Addendum 2 for RFB 943500-01

Project Name: DNR HCR Hotel Roof Replacement
RFB#943500-01
DAS Project #: 9453.00
Date: 4/18/2025

Addendum #02: Meeting Minutes, Procurement Questions & Document Changes

ROOF PLAN - AREAS A AND B1

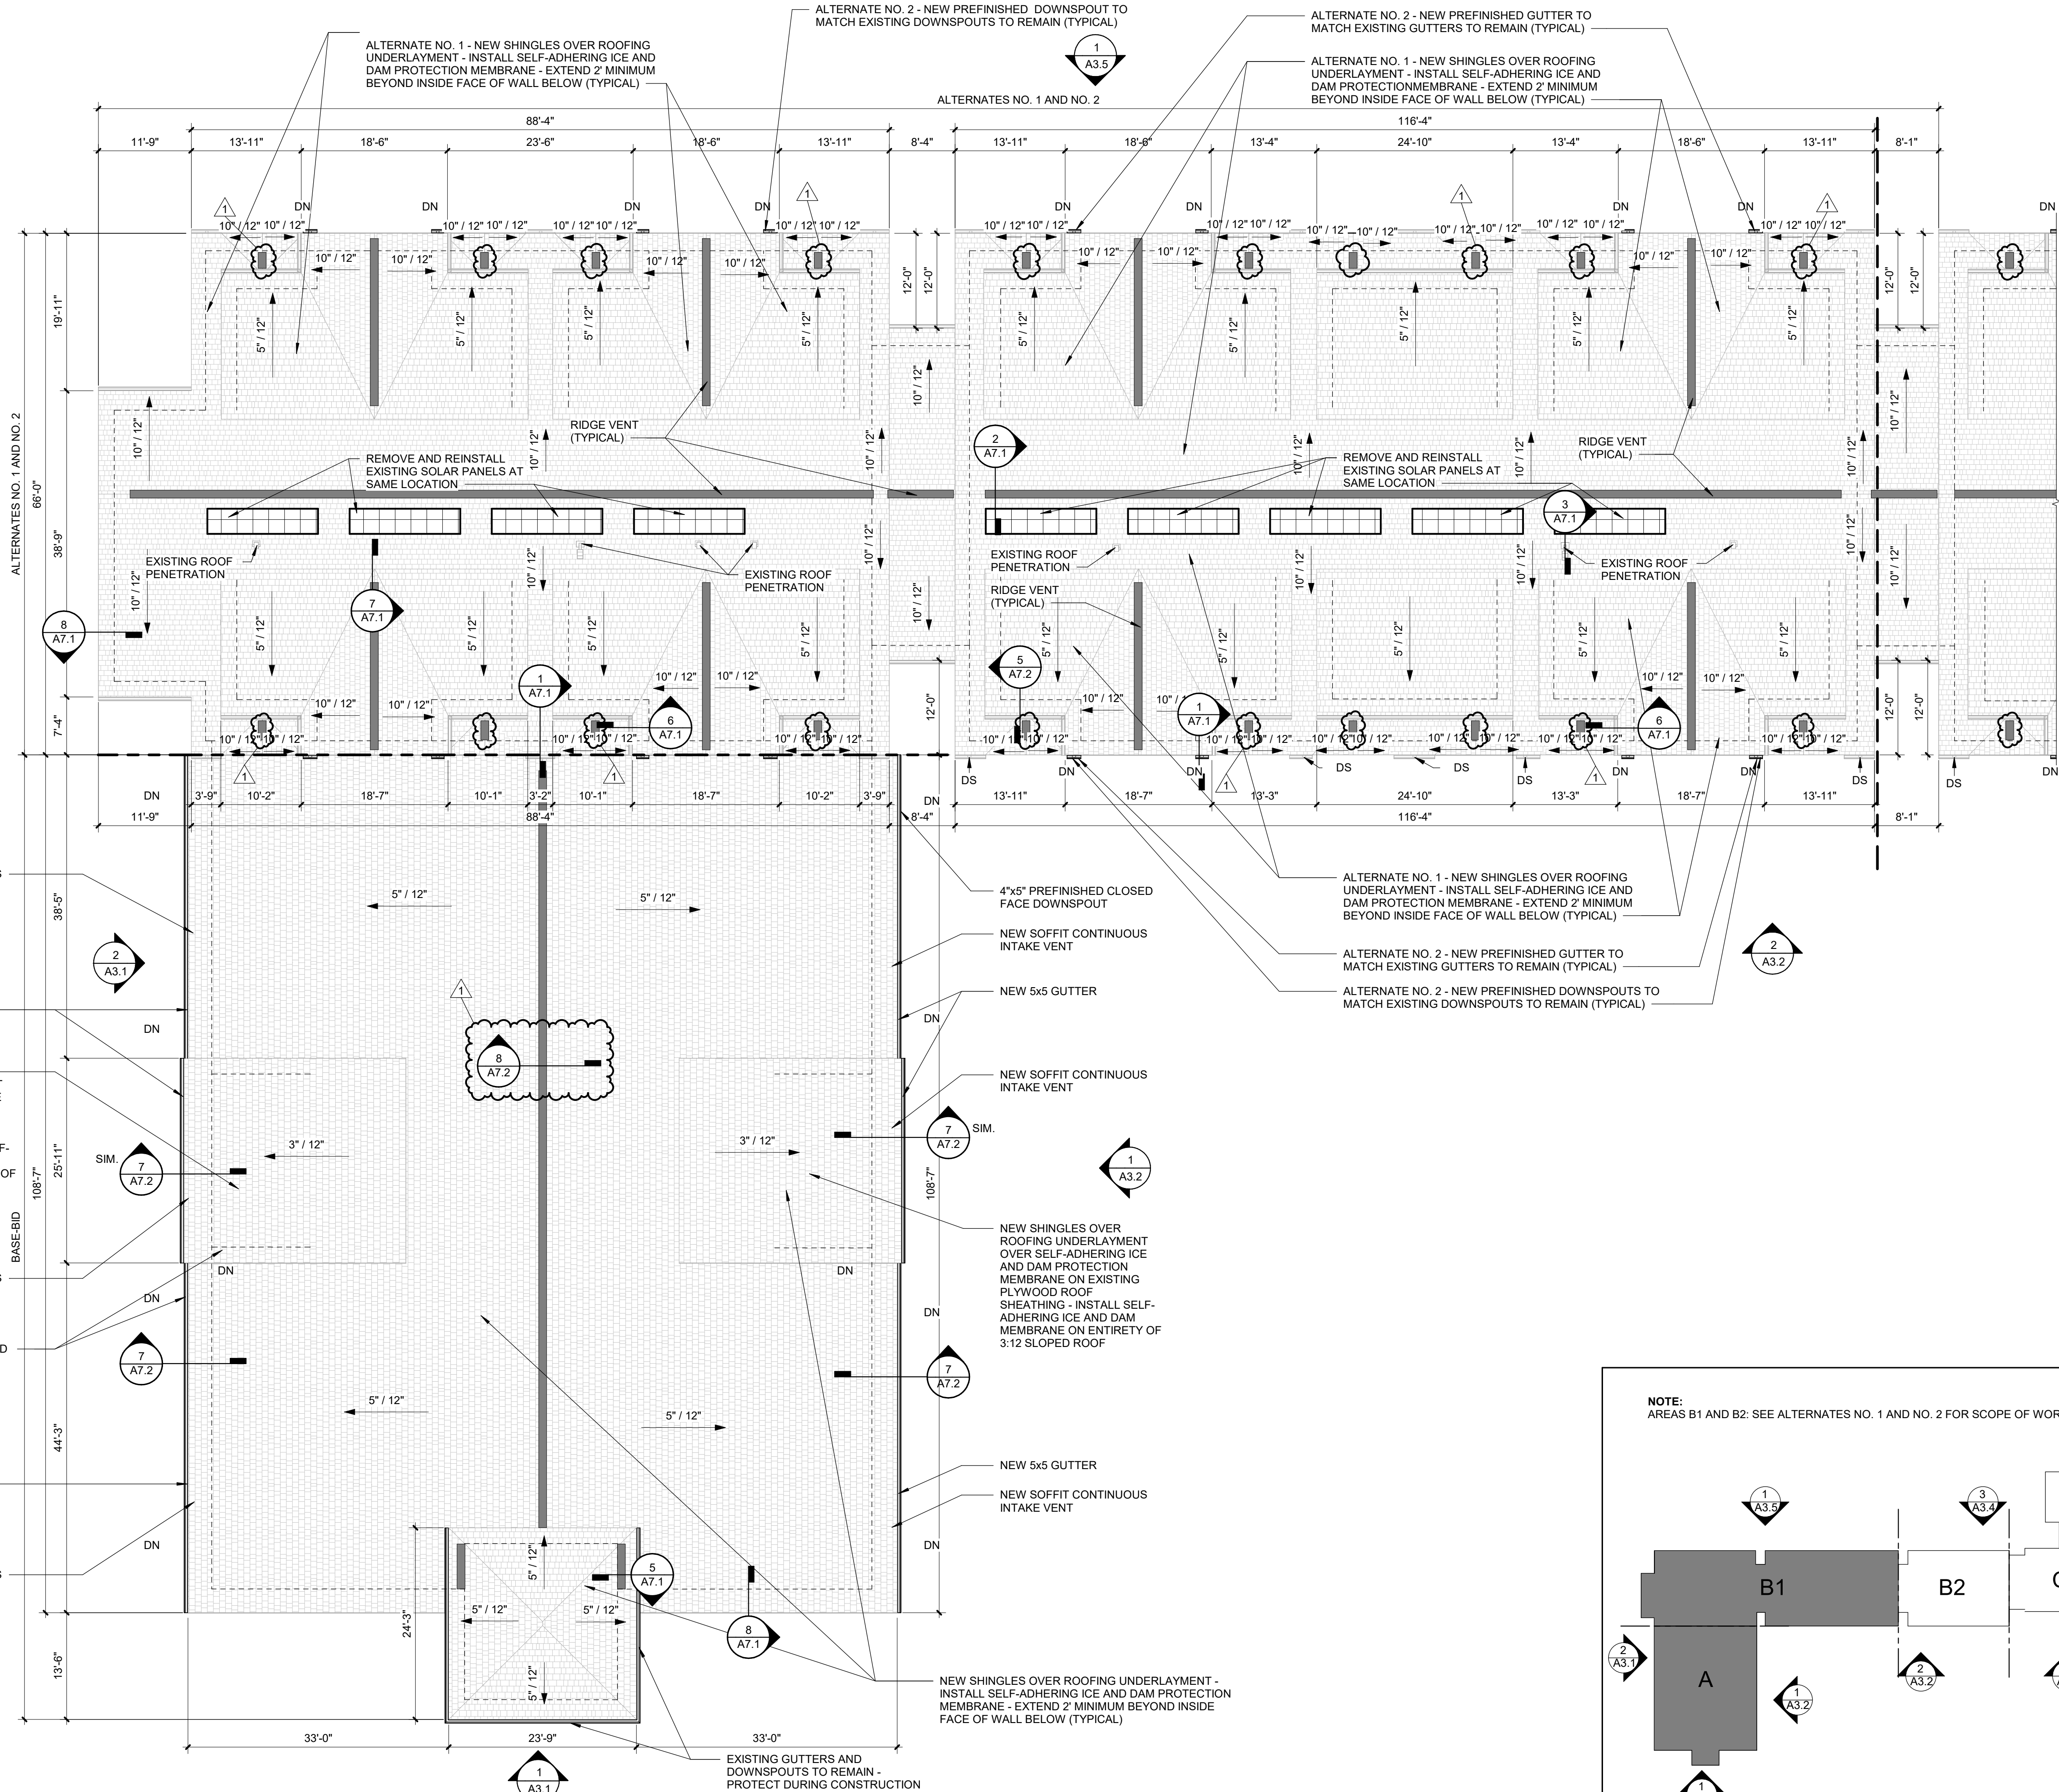
1. CHANGE ridge detail callout to 8/A7.2 at Area A.
2. ADD ridge vents on small dormer roofs as part of Alternate No. 1.

ROOF PLAN - AREA C2

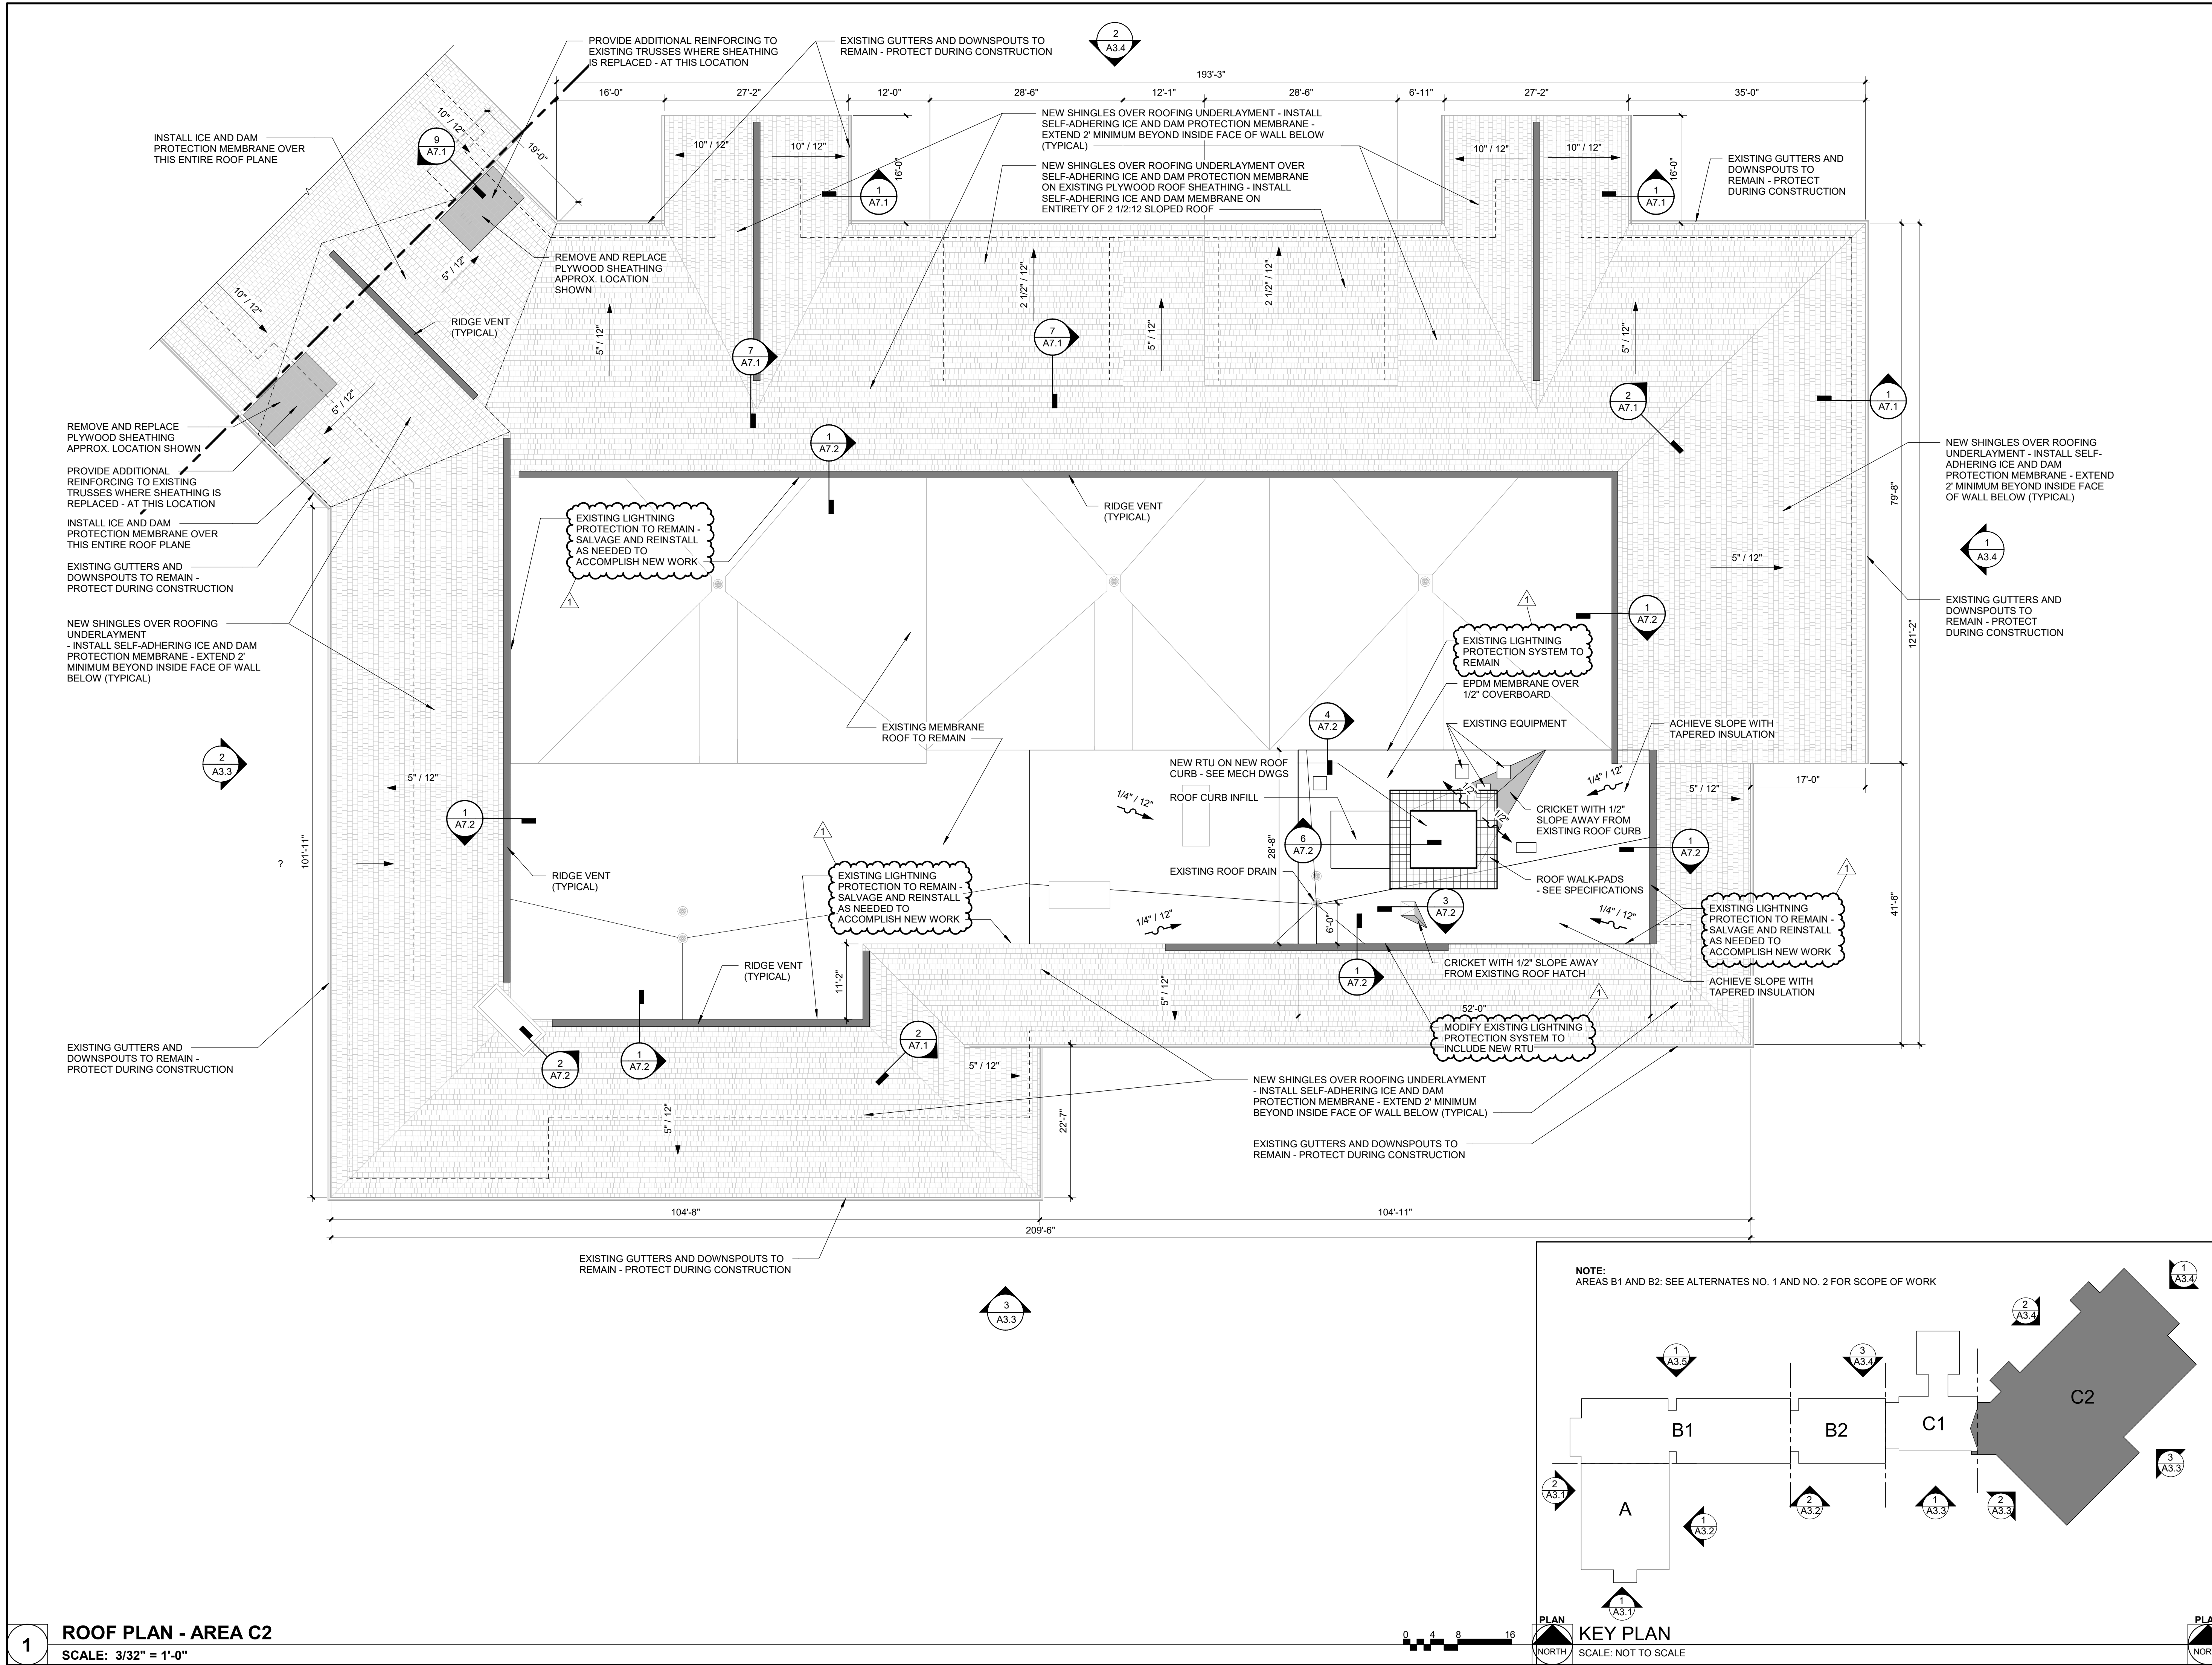
1. ADD notes referencing existing lightning protection.

6 ROOF CURB INFILL AND NEW CURB DETAIL
SCALE: 1 1/2" = 1'-0"

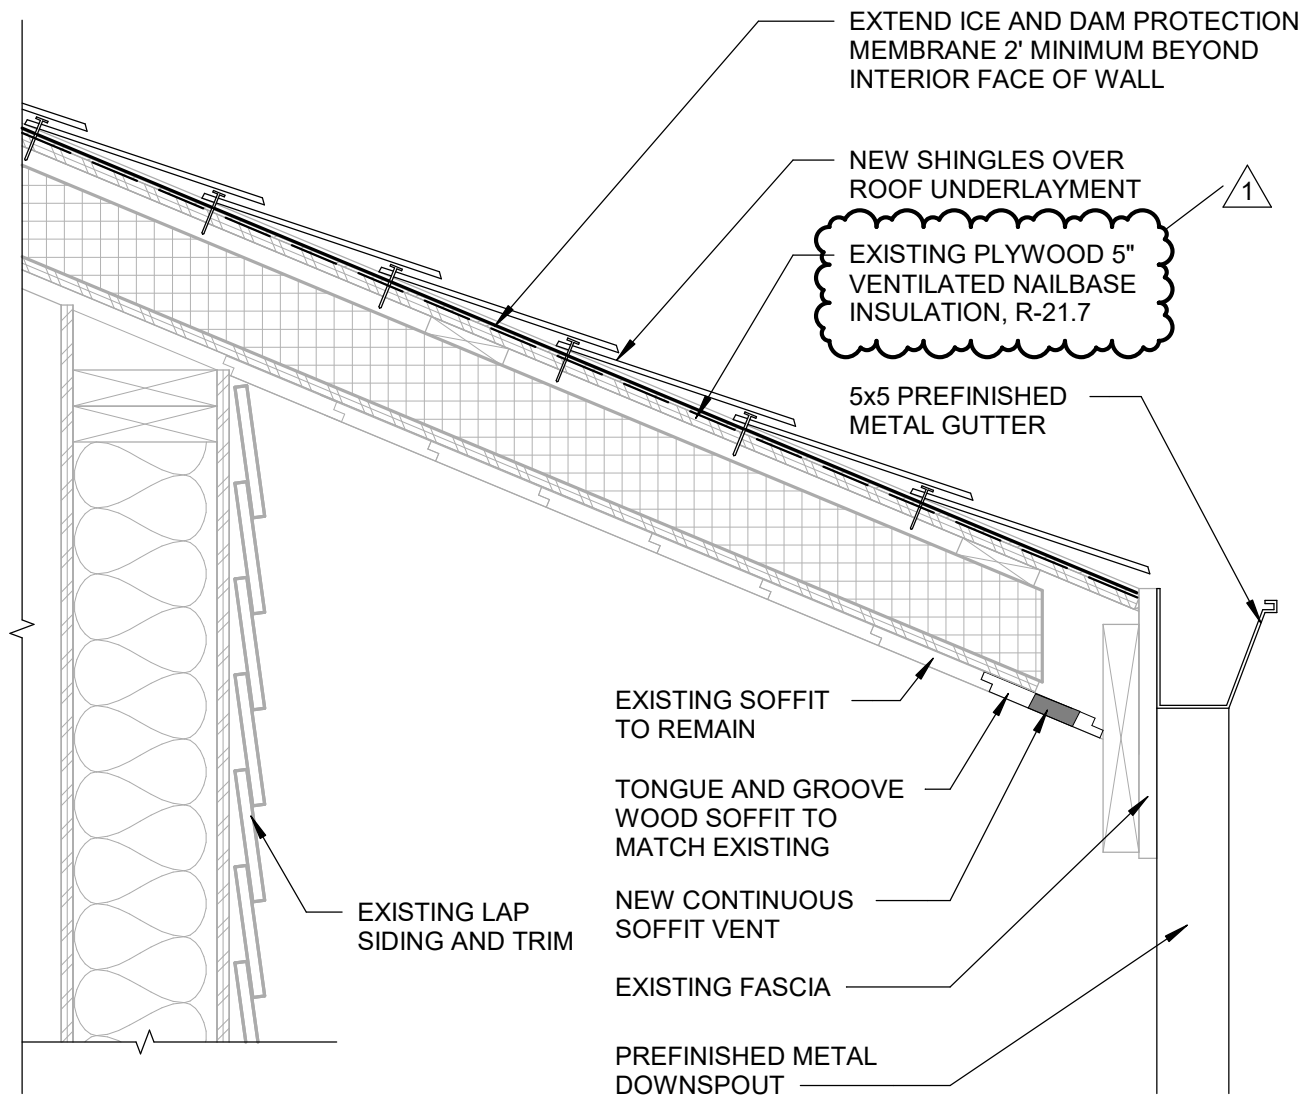
- A7.2 Detail 6 shows Insulation during the pre bid meeting the Contracting Manager mention that there is single ply, gypsum coverboard, wood deck. Pictures of Core test will confirm.

- Existing drawings detail confirms.
- Asphalt Roof
 - Shingle Color
 - The design intent is to match the cabins on the property which are 'Driftwood' by Owens Corning. But this is an open spec.

2 ROOF AT CHIMNEY DETAIL
SCALE: 1 1/2" = 1'-0"

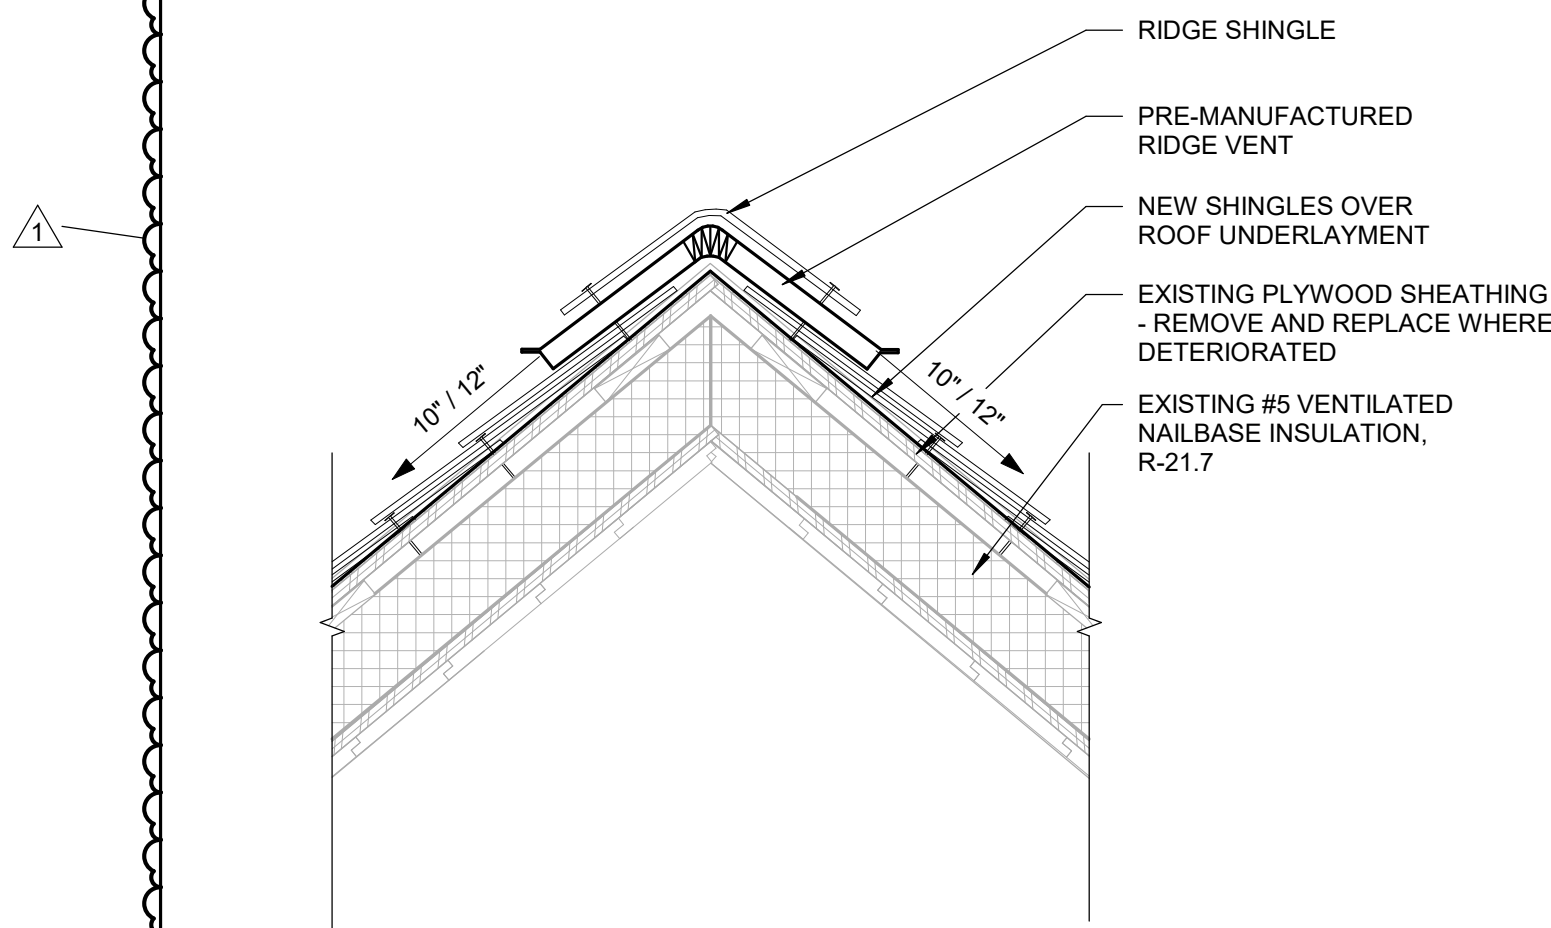
1. Detail 1: REVISE vertical extents of new membrane roof.
2. Detail 2: CLARIFY existing roof ventilated nailbase insulation system as shown in existing drawings.
3. Detail 4: REVISE vertical extents of new membrane roof.
4. Detail 6: CLARIFY existing roof system. ADD coverboard and plywood to infill scope.
5. Detail 7: CLARIFY existing roof ventilation as shown in existing drawings.
6. Detail 8: ADD existing ridge roof ventilation detail as shown in existing drawings.
